# **Appendix N**

## Comments and Responses

**Updated Draft Environmental Assessment and Draft Section 4(f) Determination  
ALP Phase I Improvements at BWI Marshall Airport**

**Draft Environmental Assessment and Draft Section 4(f) Determination Proposed Improvements 2016-2020 at BWI Marshall Airport**  
**Public and Agency Comments**

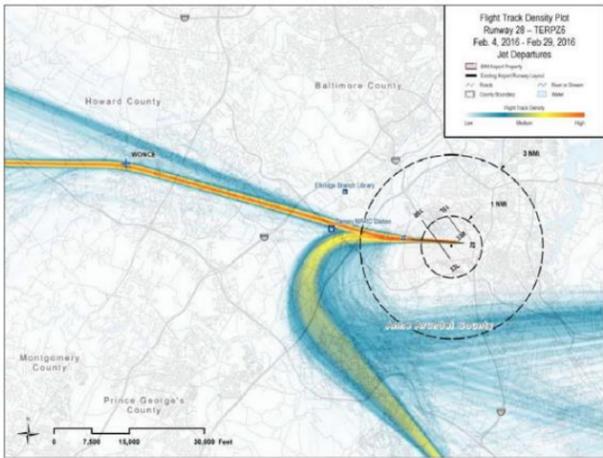
9	Drew Roth	1/30/18	Noise	<p>2. The noise contours in Appendix K do not reflect the actual flight paths under Nextgen.</p> <p>Prior to Nextgen, departures from Runway 28 proceeded straight on a line with the runway.<sup>1</sup></p> <p>(<sup>1</sup> Presentation to FAA Roundtable July 2017  <a href="http://maacommunityrelations.com/_media/client/anznoiseupdate/2017/20170718_Roundtable_Presentation_HMMH.pdf">http://maacommunityrelations.com/_media/client/anznoiseupdate/2017/20170718_Roundtable_Presentation_HMMH.pdf</a>)</p>	<p>Both TERPZ 5 and TERPZ 6 were modeled in the Existing Condition, No Action, and Proposed Action Alternatives, which result in the noise contours turning slightly to the north. Specifically, on February 4th, 2016, departure procedure TERPZ5 was changed to TERPZ6 by the FAA. This change affected jet departure flight tracks from Runway 15R making right turns to the west and northwest as well as Runway 28 making a slight right turn towards west and northwest. For future conditions, tracks reflective of the TERPZ6 procedure were applied to the noise analysis. Figure K-1, in Appendix K of the BWI Marshall EA illustrates the TERPZ flight tracks before and after the procedure change.</p> <p>Additionally, Appendix K provides a comparison of the BWI EA 2020 Proposed Action noise contours and the Part 150 Study 2019 noise contours, see specifically Figure K-8. The most significant increase is expected to occur to the northwest of the airport between Runway 10 and Runway 15R. Areas to the southeast of the airport along the Runway 15R/33L extended centerline are also expected to experience an increase of noise level. This comparison provides clear evidence that procedural changes brought about by FAA change to the TERPZ procedure were included in the noise analysis for the BWI Marshall EA.</p>	No change.

#	Reviewer	Date	Page/Section	Comment	Response	Status
				<p style="text-align: center;"><b>TERPZ6, Runway 28</b></p>  <p style="text-align: center;">Source: MAA, 2016</p> <p>It appears that the noise contours in the subject EA are based on the pre-Nextgen flight patterns. If they were based on the current Nextgen flight patterns, one would expect the westernmost point of the noise contour to be to the north of a straight line from Runway 28. The difference is readily apparent if one compares the point at which the flight paths intersect MD 100.</p>		
10	Drew Roth	1/30/18	Noise	<p>3. The difference between the flight paths shown in this EA and in the DC Metroplex EA is significant.</p> <p>If the noise contours were aligned with the Nextgen flight patterns, the Oxford Square development of 1400 residences, Thomas Viaduct Middle School, and Hanover Hills Elementary School would be within the 65 DNL contour. If the Purpose and Need Statement for the subject EA is correct, and the proposal is required to meet anticipated demand, one would expect the noise contour to increase over these communities, resulting in an increased significant impact.</p> <p>Furthermore, the DC Metroplex EA clearly states there will be no significant impacts due to flight path changes under 3000 feet AGL. This EA received a FONSI based on this assertion. However, it is apparent that the rightward turn has created a significant impact on the Oxford Square residences, which are likely now within the 65 DNL contour, and where aircraft routinely fly directly overhead at an altitude of approximately 1200 feet AGL.</p>	<p>TERPZ 5 and TERPZ 6 were included in the noise model (see Figure K-1). Projects evaluated in the Draft EA are needed to meet current FAA design standards, enhance airfield safety and efficiency, and accommodate existing and anticipated demand. The implementation of the NextGen flight procedures and any associated revisions to noise contours are unrelated to the proposed improvements included in this Draft EA and Draft Section 4(f) Determination and therefore are not discussed in detail. Nonetheless, they are included in the noise modeling for both No Action and action alternatives.</p> <p>This Draft EA focuses on ground infrastructure improvements whereas the NextGen DC Metroplex EA focused on the flight path changes. The implementation of the NextGen flight procedures and any associated revisions to noise contours are unrelated to the proposed improvements included in this Draft EA and Draft Section 4(f) Determination. However, procedural changes implemented as part of the DC OAPM are incorporated into the noise analysis for all alternatives through the review of radar tracks actually flown by aircraft using the procedures. The noise analysis for the Proposed Action shows noise increases only around the proposed Airline Maintenance Facility due to engine maintenance run-ups, this area is the only notable change in the noise contours when compared to the No Action Alternative. This change in noise occurs within areas that are compatible with the proposed action (i.e. commercial and manufacturing and production).</p>	No change.

Figure 1A Runway 28 Departures - shows specific examples of aircraft flying where they were not flying prior to DC Metroplex/NextGen.

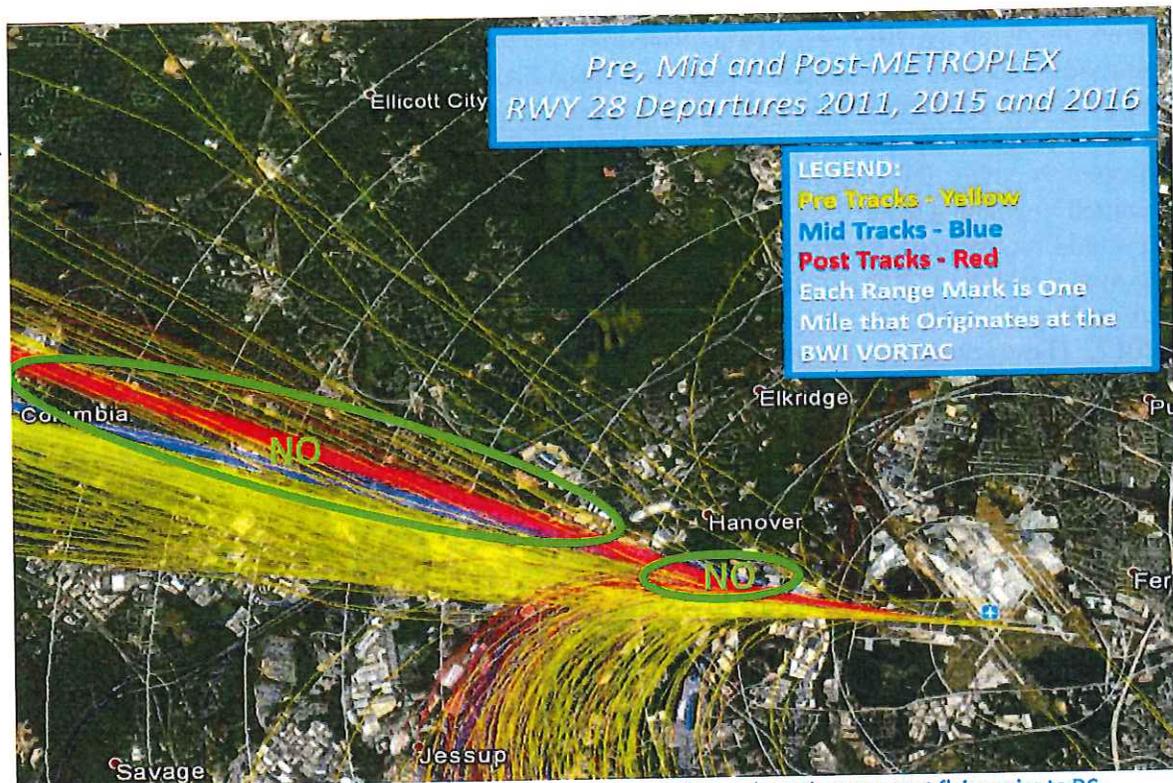
1. New flight paths have been created by DC Metroplex/NextGen; FAA must revert to old flight paths. Thousands of community residents have observed aircraft flying along flight paths that were not being flown previously. See Figures 1A, 2A and 3A and FAA flight path diagrams in Attachments 1 and 6 for comparison and as representative examples. These new flight paths include, among others:

Figure 2A Runway 15 Departures - shows specific examples of planes flying where they were not flying prior to DC Metroplex/NextGen.

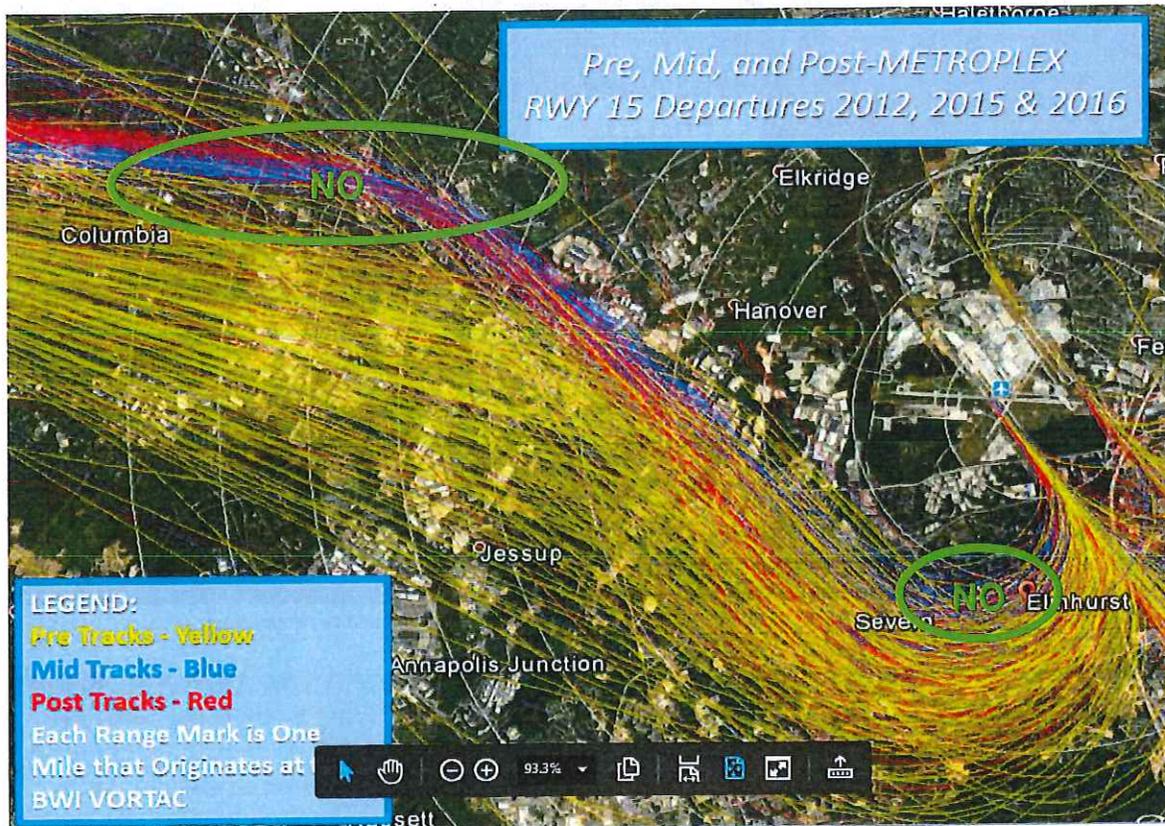
2. DC Metroplex/NextGen has resulted in a concentration of flight paths in narrow corridors; FAA must revert to old procedures that were effective in achieving dispersion. The concentration of low flying aircraft along the departure and arrival flight paths has been disastrous for residents underneath them. Numerous studies have demonstrated the harmful effect on mental and physical health due to aircraft and low frequency noise. In addition to the health effects, there is a questionably constitutional taking by the FAA of the residents' quiet and peaceful enjoyment of their homes and attendant economic loss due to lower property values. A comparison of pre- and post-DC Metroplex/NextGen flight paths as shown on Attachments 1 and 6 clearly shows the concentration of flight paths post-DC Metroplex/NextGen and that those under the flight paths would be significantly impacted is intuitive.

Figure 4 Vertical Profiles – shows how planes are flying at lower altitudes than necessary, as has been observed on all arrivals, particularly bothersome with arrivals on Runway 33L and Runway 10.

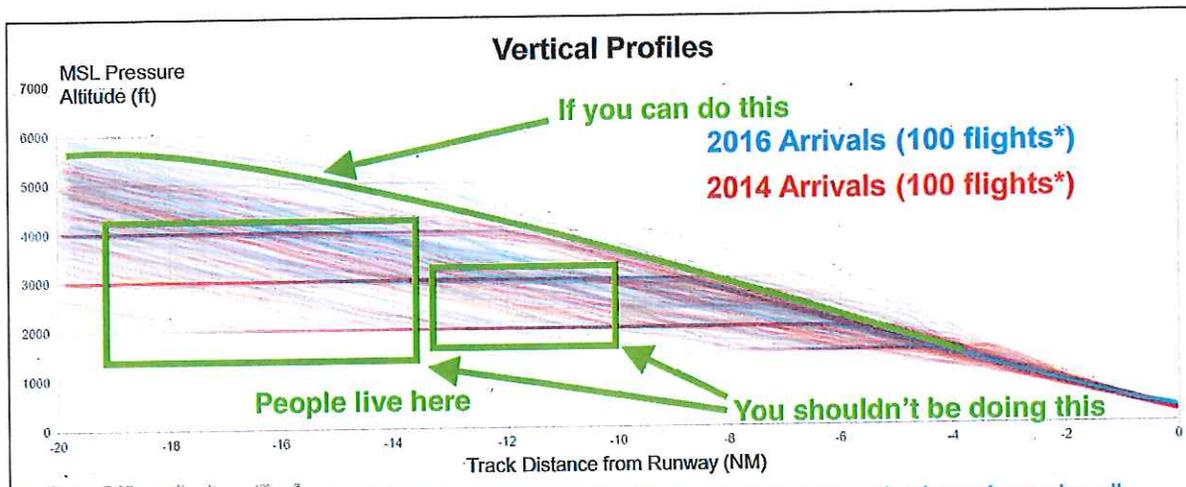
3. FAA procedures permit aircraft to fly at altitudes too low; procedures must be modified to require aircraft to fly at the highest safe altitude at all times during departures and arrivals. Residents universally state that aircraft are flying lower under the DC Metroplex/NextGen scheme than previously. We understand there is conflicting data about how low aircraft are flying and issues regarding whether representations regarding aircraft altitude in DC Metroplex environmental assessment were accurate. As stated by FAA operations representatives for BWI approach control, the frequent ATC procedure of clearing aircraft for visual approaches has had the effect of alleviating an aircraft's obligation to comply with published arrival and approach procedure altitudes resulting in much lower flying aircraft. This has directly translated into an unacceptably lower altitude for regular flight operations. For arrival aircraft this has affected flights from as far out as the RAVNN waypoint on the RAVNN arrival and their joining of the final approach corridor into 33L at lower than IFR standard glideslope intercept altitudes. For 15R departures this has resulted in aircraft turning at lower altitudes; altitudes should be restored to previously established altitudes and the turn should be restored to 1 DME.

# Jet Departures, April 2014

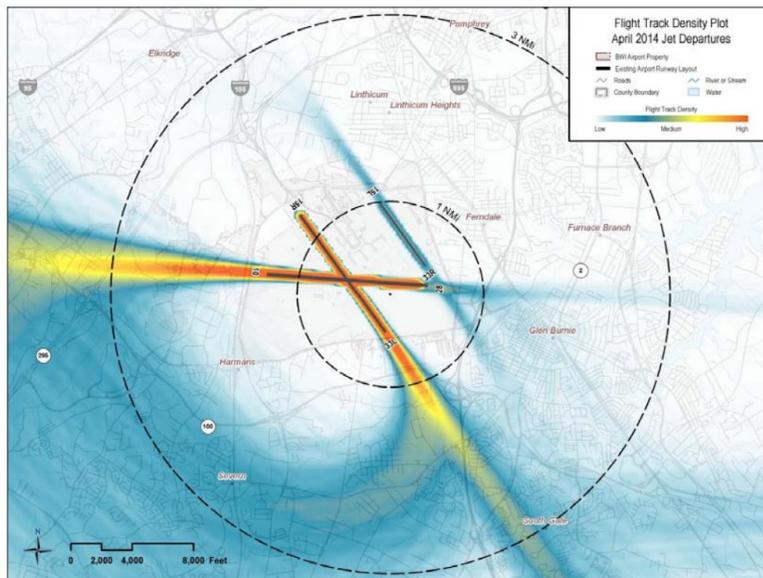
However, Figure K-7 shows the noise contour for the proposed action and the no action alternative to be nearly identical. This cannot be reconciled with the Statement of Purpose and Need, which clearly states “The Proposed Action includes those improvements required to accommodate the projected activity levels through 2020.”

However, under the Nextgen TERPZ 5 and TERPZ 6 procedures, there is a right turn soon after departure.
